◆ PACIFICORP
ELECTRIC OPERATIONS GROUP

September 10, 1990

RE: PROPOSED DISCHARGE TO DEER CREEK (EMERY COUNTY)

FIGURE 1. Location Map for the sampling sites.

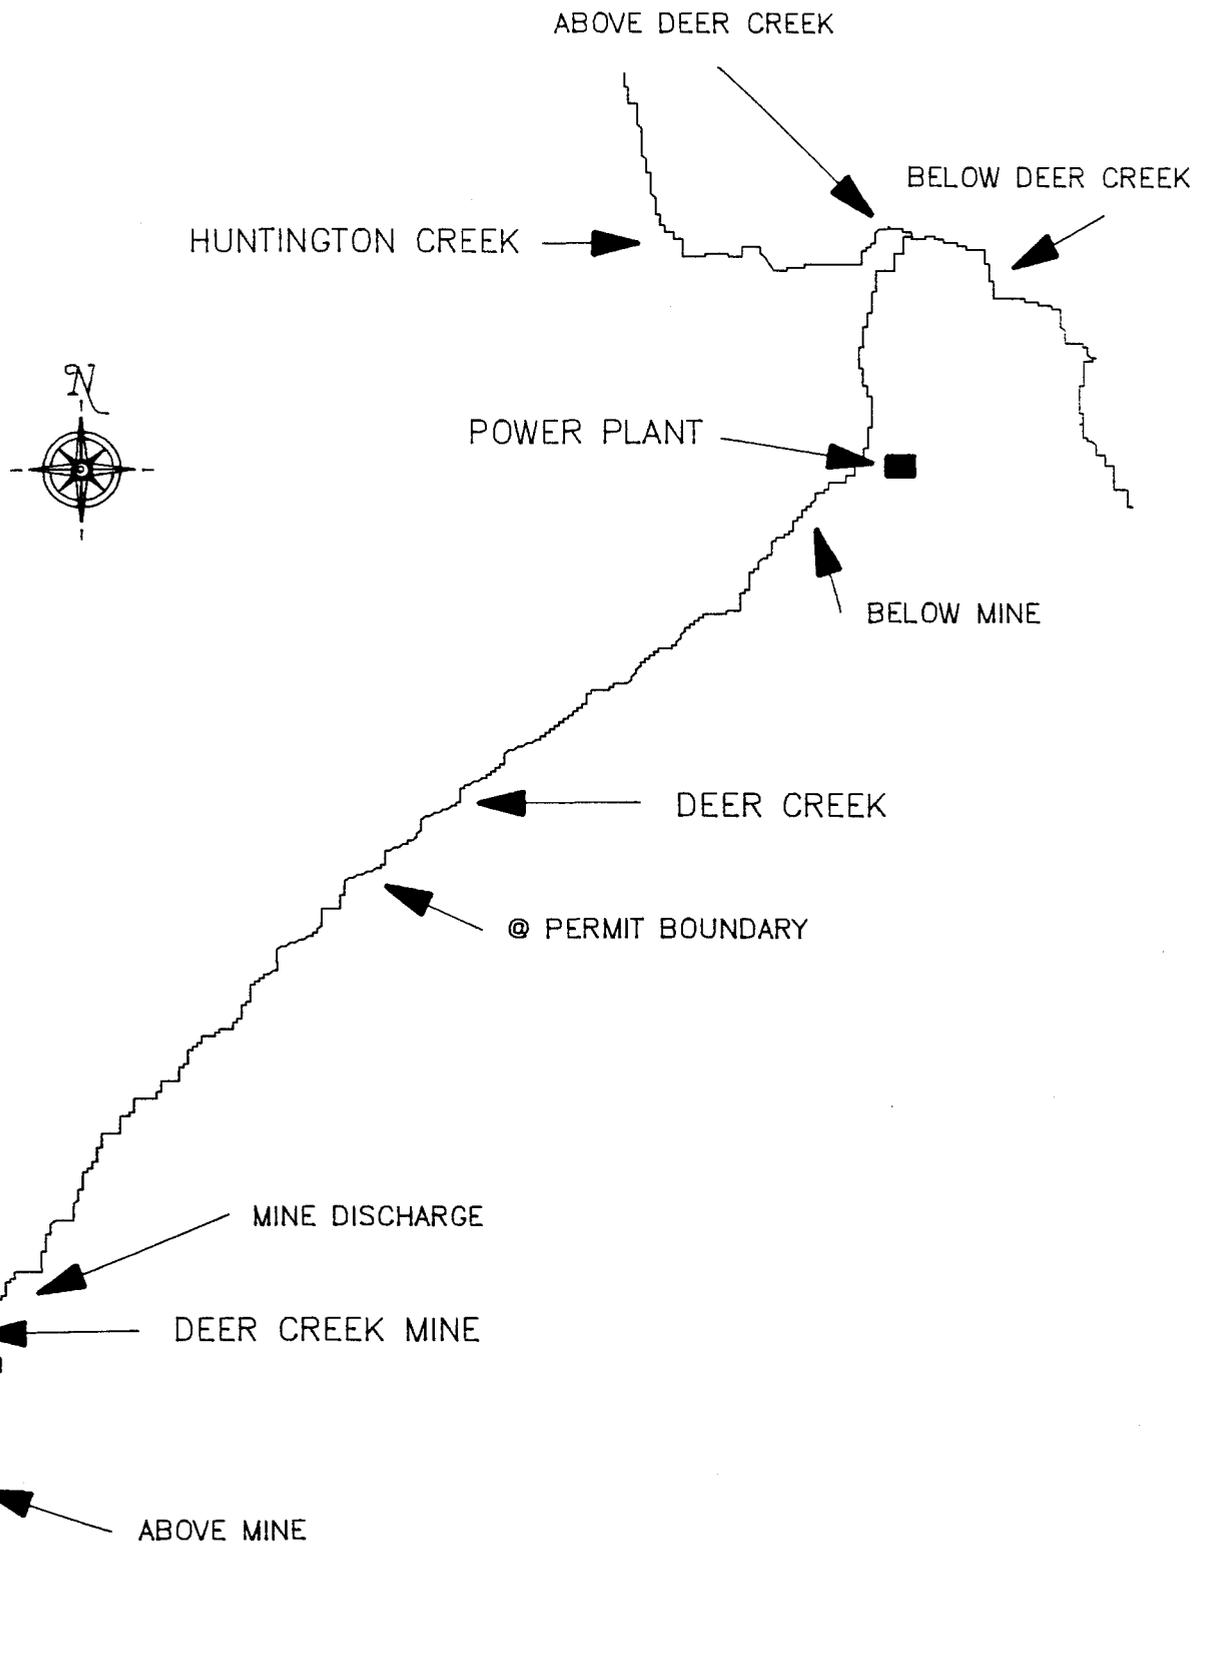
4. What are UP&L plans for monitoring water quality in Deer Creek and Huntington Creek during the initial discharge and afterwards?

During this time, samples will be taken at the four (4) stations along Deer Creek and at the two (2) stations on Huntington Creek above and below the confluence with Deer Creek, see Figure 1.

Response: UP&L will monitor the discharge at the locations shown on Figure 1 and in accordance with the monitoring schedule shown on Table 1 & 2. This schedule will concentrate monitoring during the initial discharge phase and then will be reduced to coincide with our normal surface water monitoring schedules that have been established in our Hydrologic Monitoring Program.
